Ventura Westside Community Planning Project

Final Environmental Impact Report

FIGURE 3.0-2

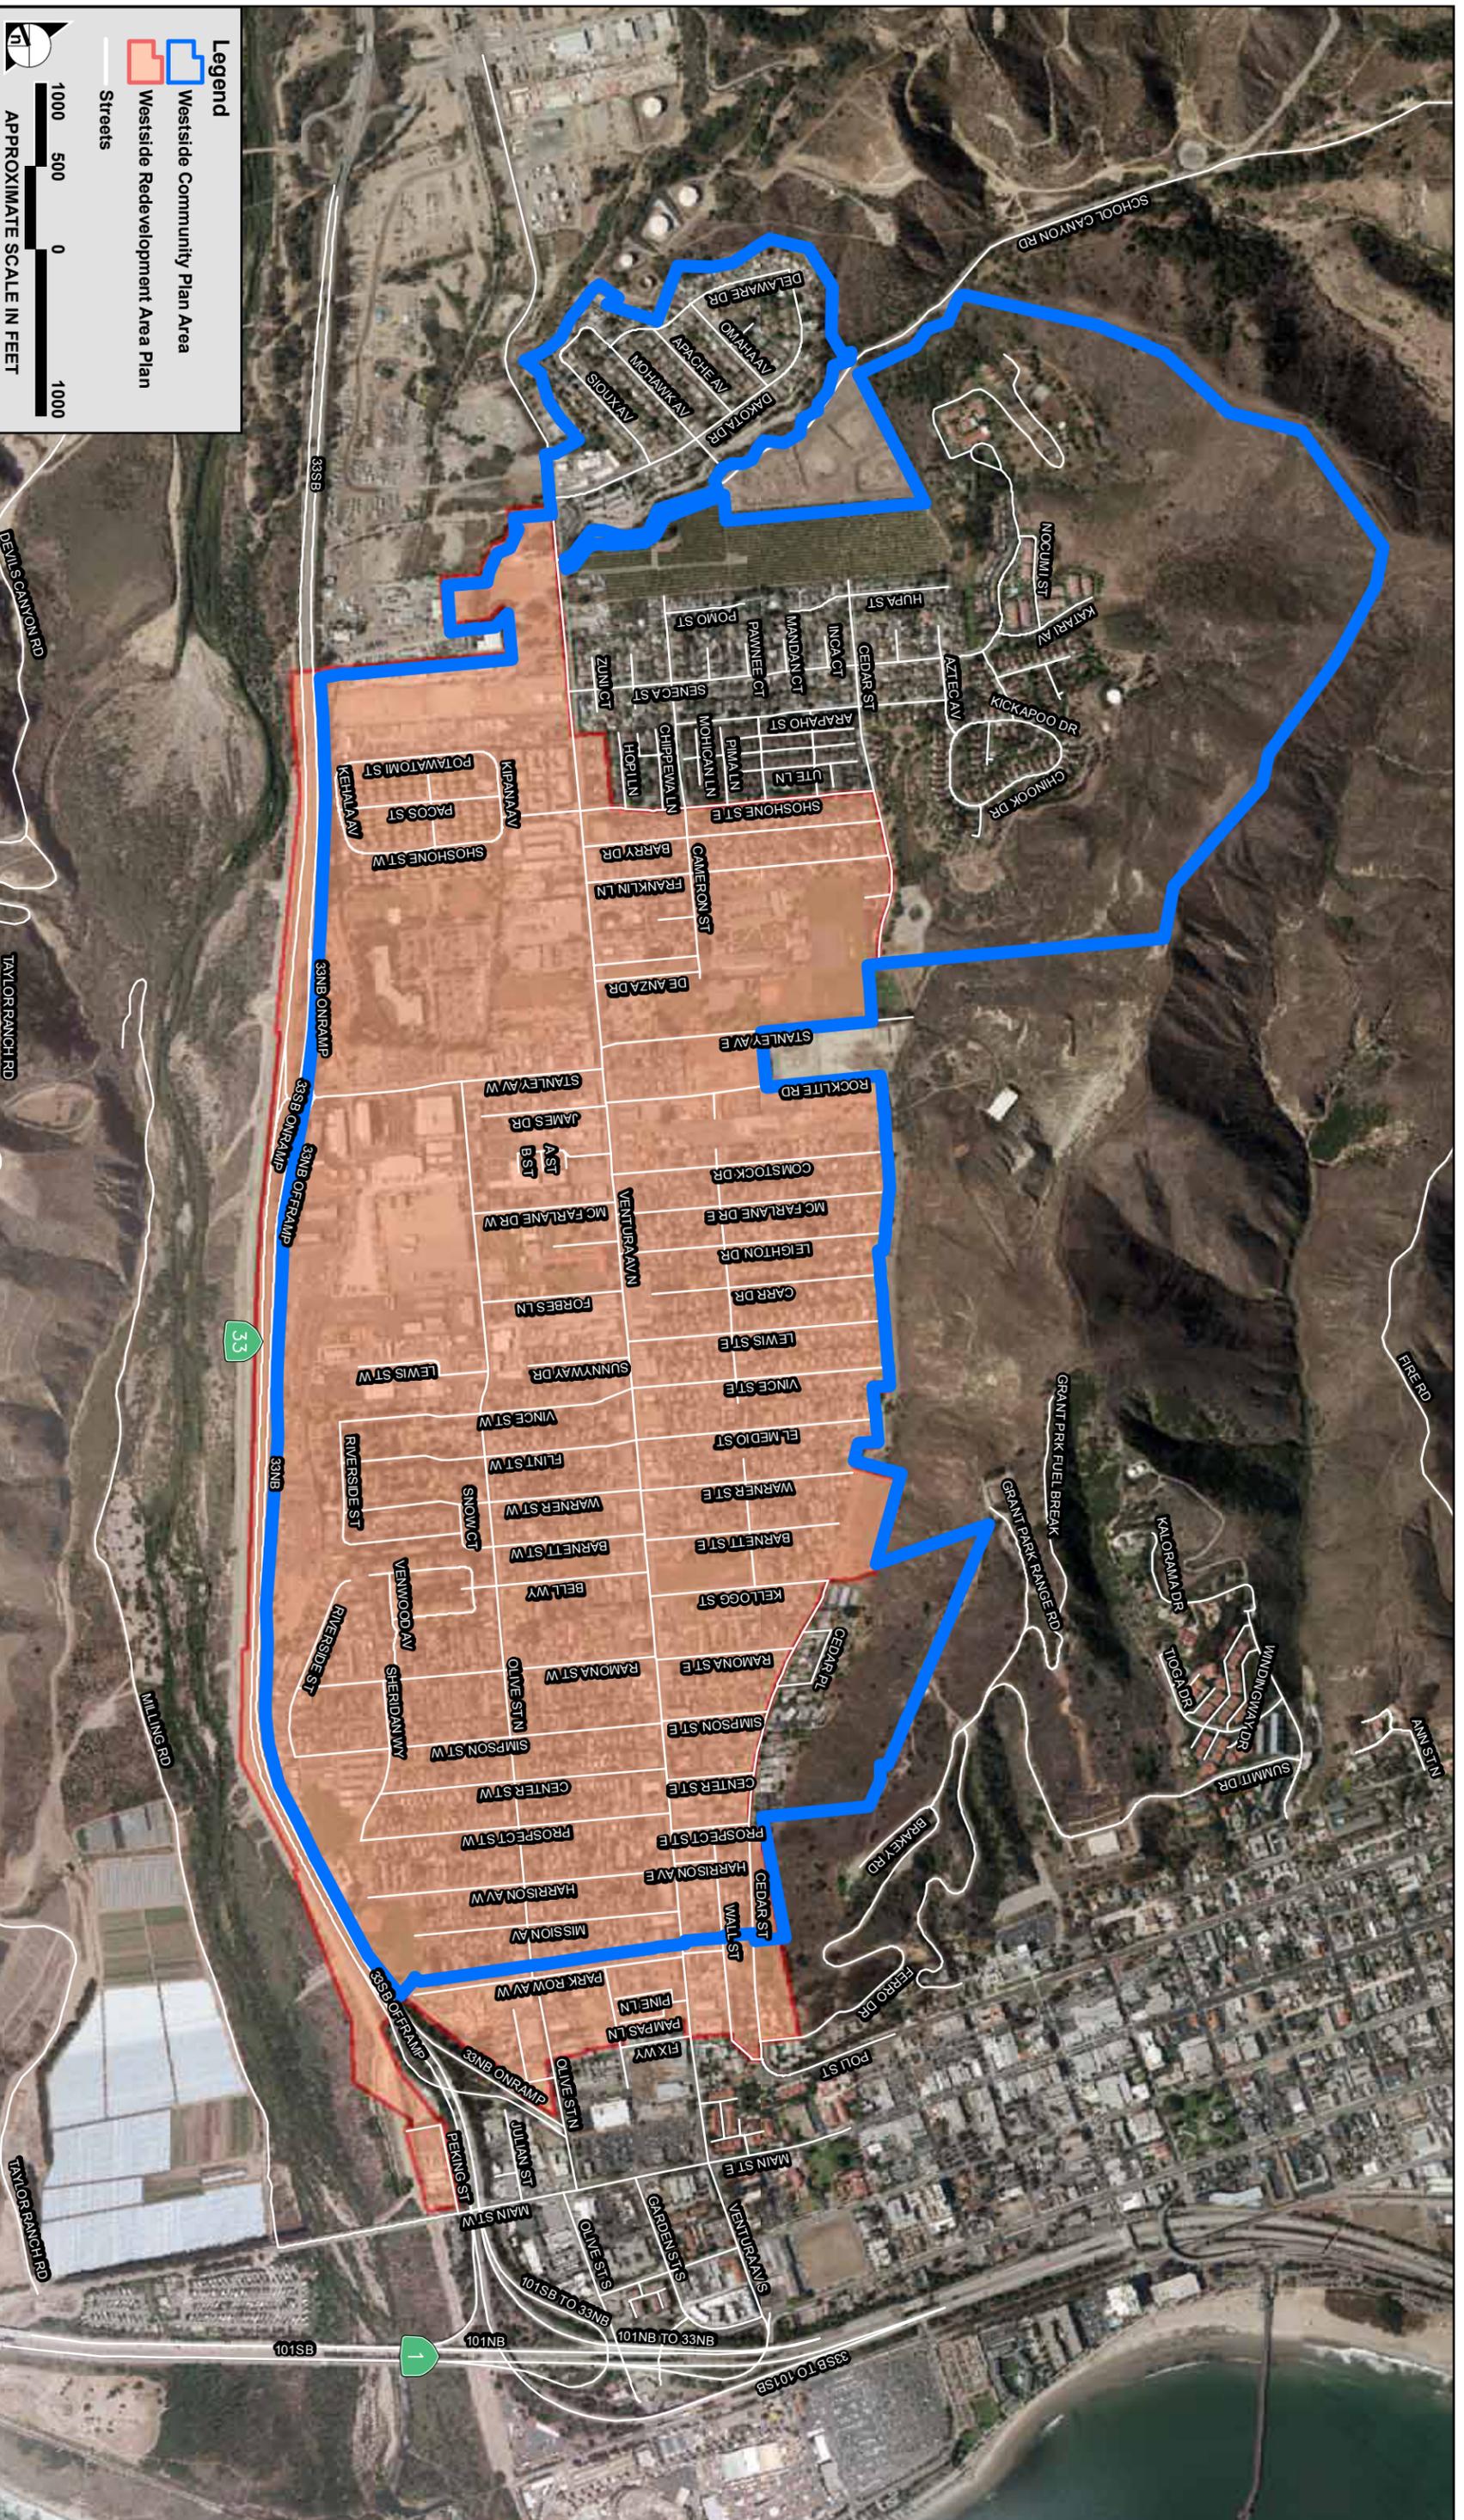
| <p>2. page 3.0-3 Boundaries of Redevelopment area in Figure 3.0-2 appear incorrect in text: ends just south of Shoshone not Barry; Dakota Drive does not exist on the west side of Ventura Avenue.</p> | 2 |
| <p>6. page 3.0-6 Please clarify whether state route 33 is within the Westside Community Planning Area as shown in Figure 3.0-2. The online City map shows the city limits east of 33 to approximately the extension of West Simpson Street; the blue line indicating the project boundary is west of highway 33.</p> | 6 |

As the Draft EIR states on page 3.0-3, State Route 33 (SR-33) forms the western boundary of the Westside Community Plan area. As such, it is located outside of the planning area. The boundary on Figure 3.0-2 has been adjusted to show this more clearly and can be found in the Final EIR.

FIGURE 4.8-2

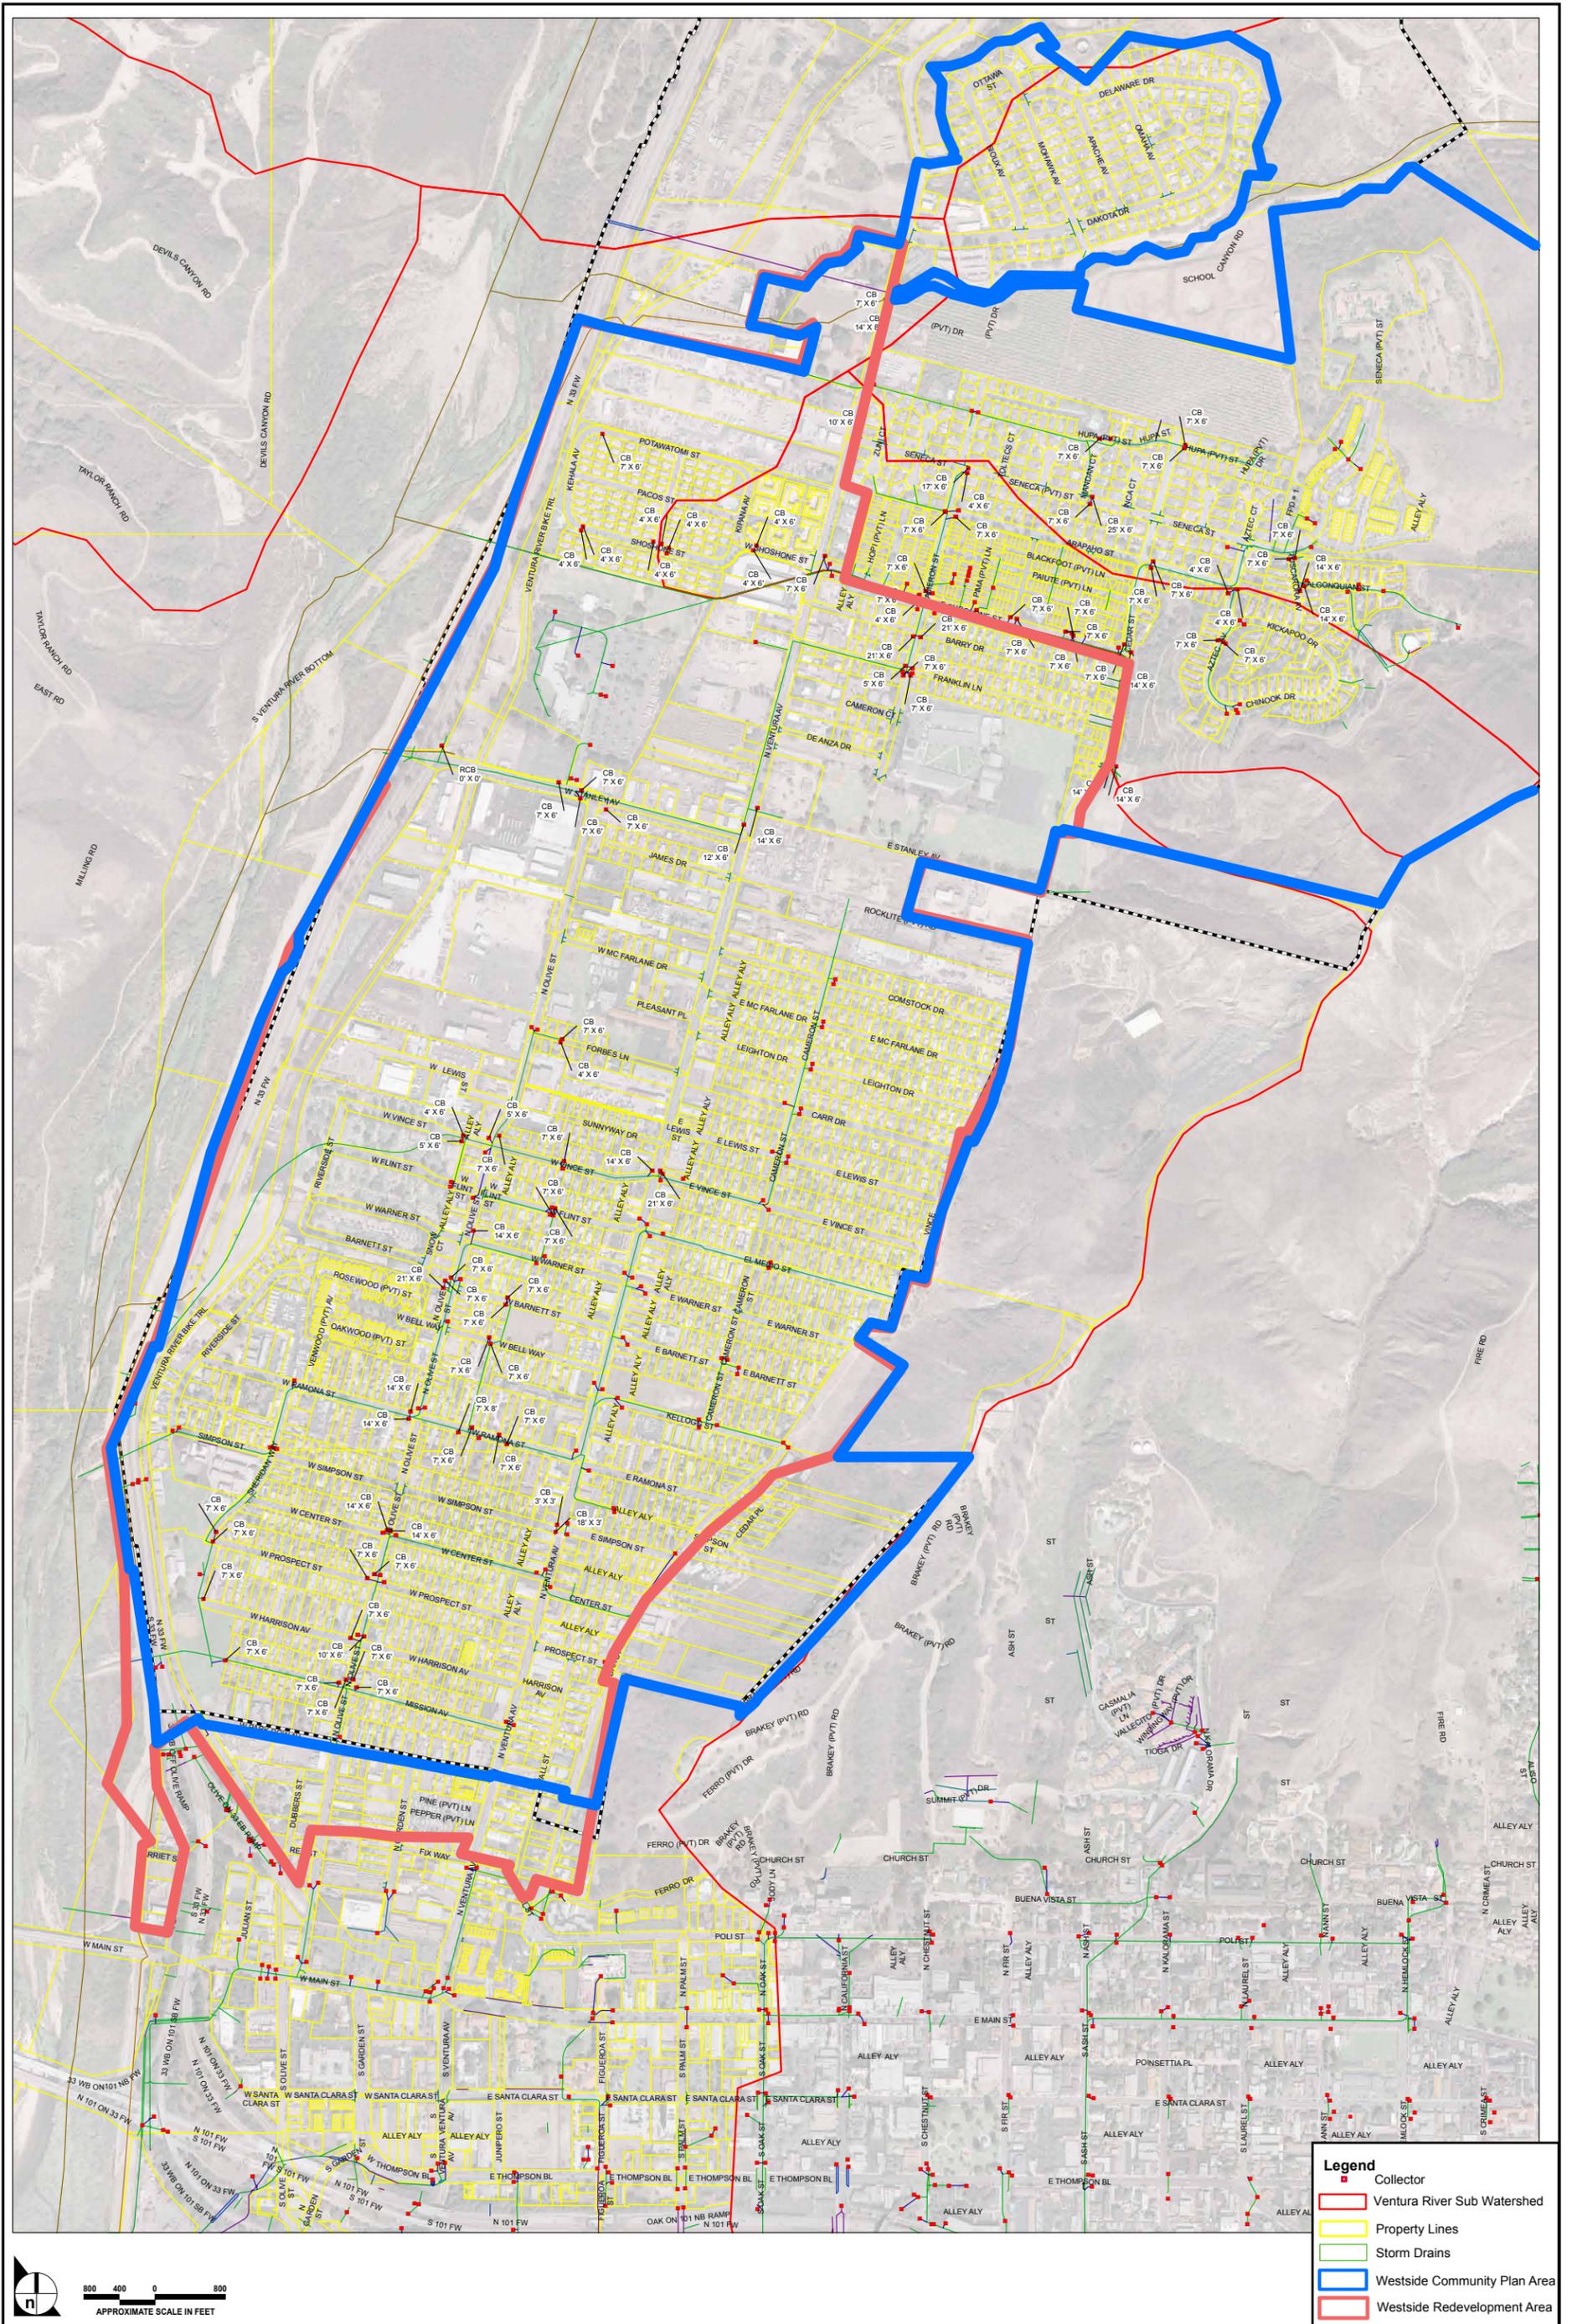
36. page 4.8-4 The blue line (Westside Community Plan Area) on Figure 4.8-2 appears to be incorrect in the vicinity of Sycamore Village (Potawatomi Street), and possibly in other locations.

The planning area boundary is shown in Figure 4.8-2. This boundary has been revised in the Final EIR.

FIGURE 4.10-6

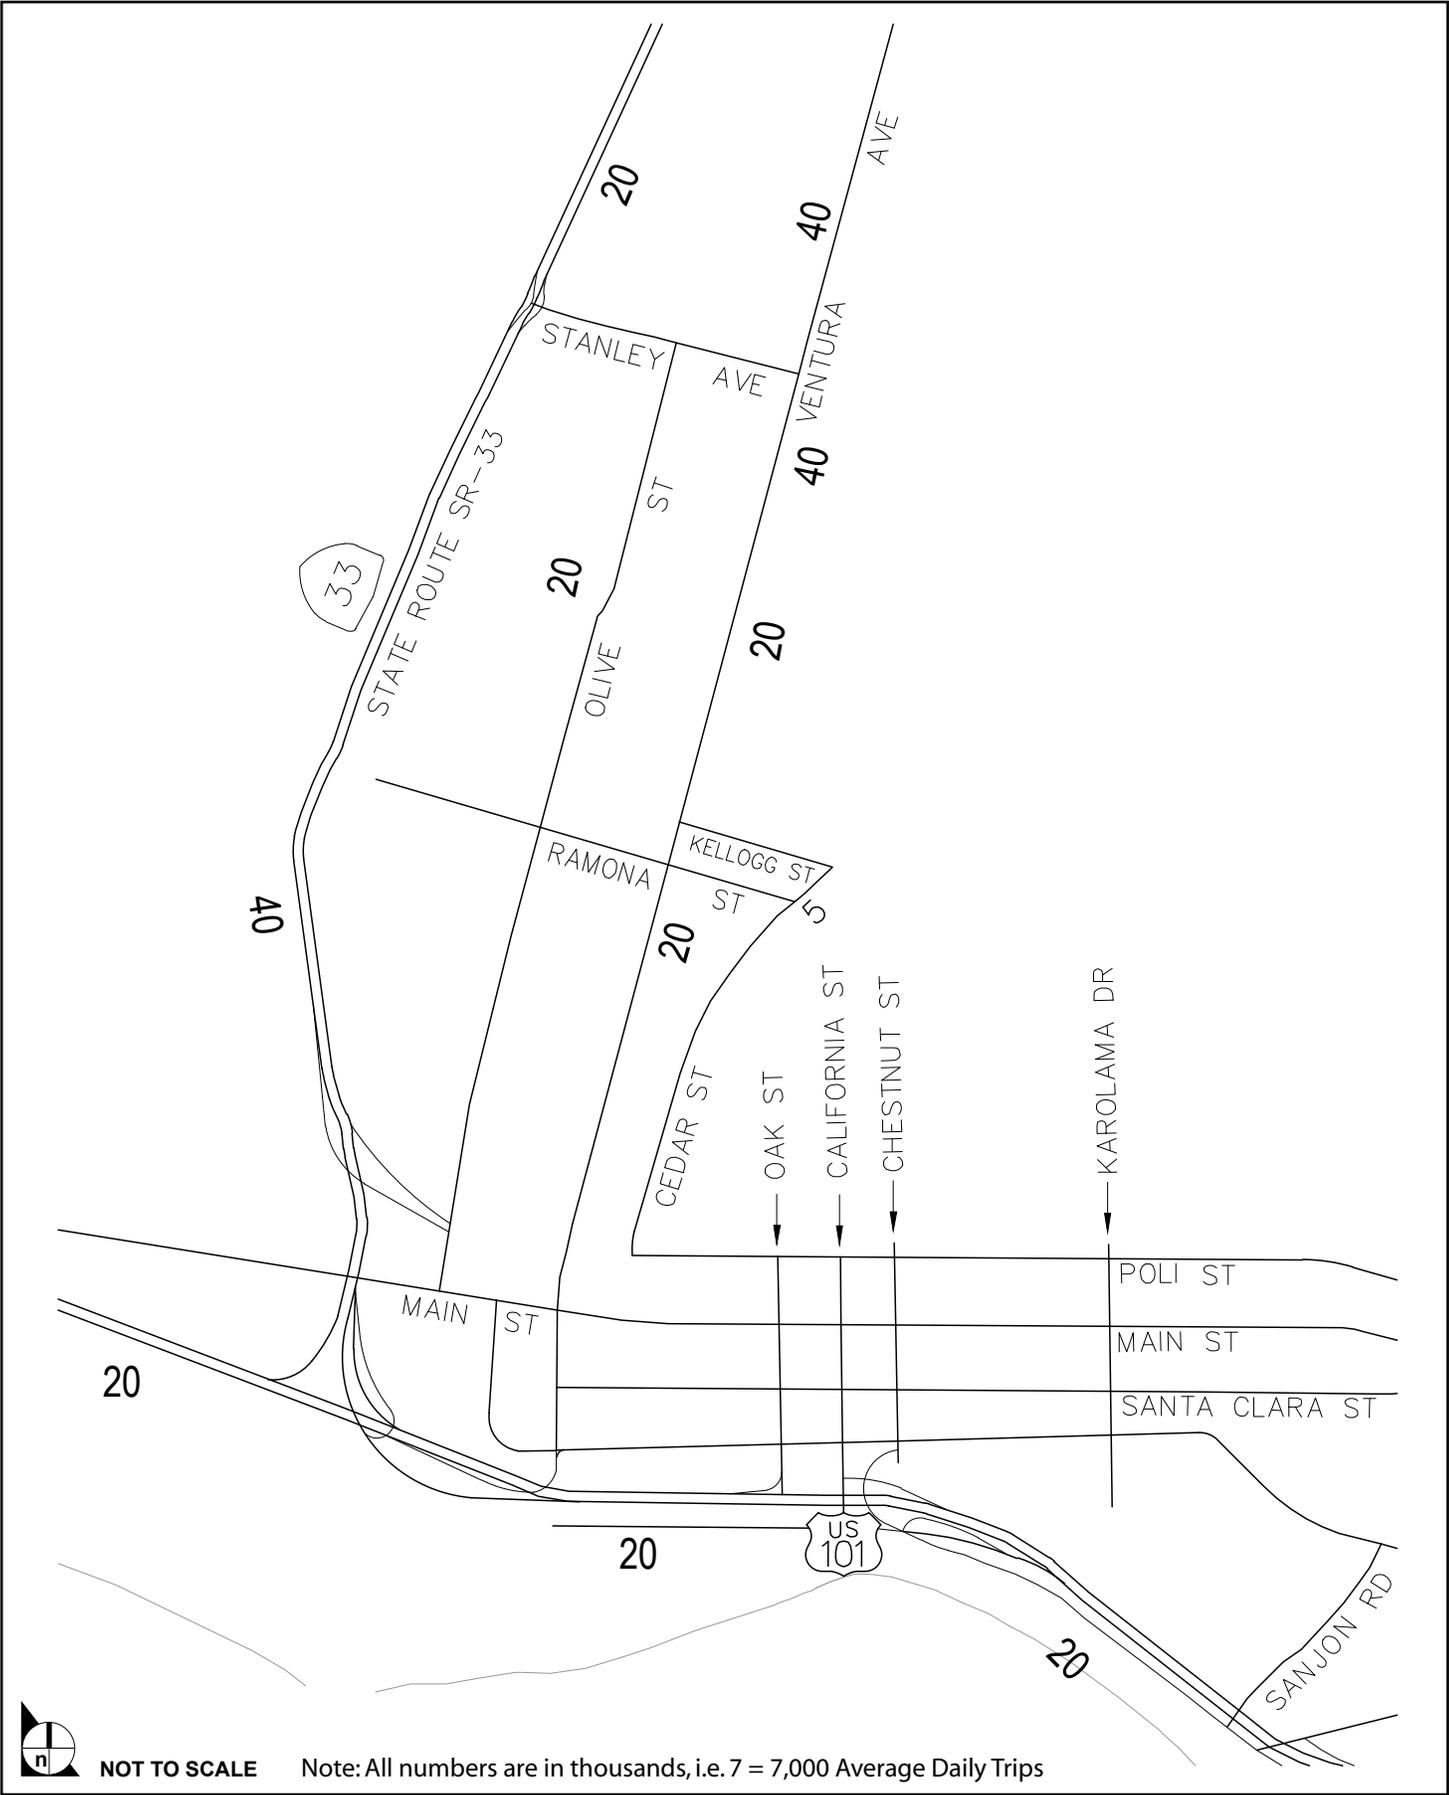
50. page 4.10-20 Figure 4.10-6 is labeled "Trip Distribution (%)". Please clarify what is shown – project impacts, cumulative, or other. Please show more detail on the Figure, including more information about trip counts rather than rounding to the nearest thousand.

Figure 4.10-6 in the Draft EIR shows the estimated trip distribution for the proposed project in thousands. The indication in the figure title that percentages are shown is inaccurate and has been corrected in the Final EIR.
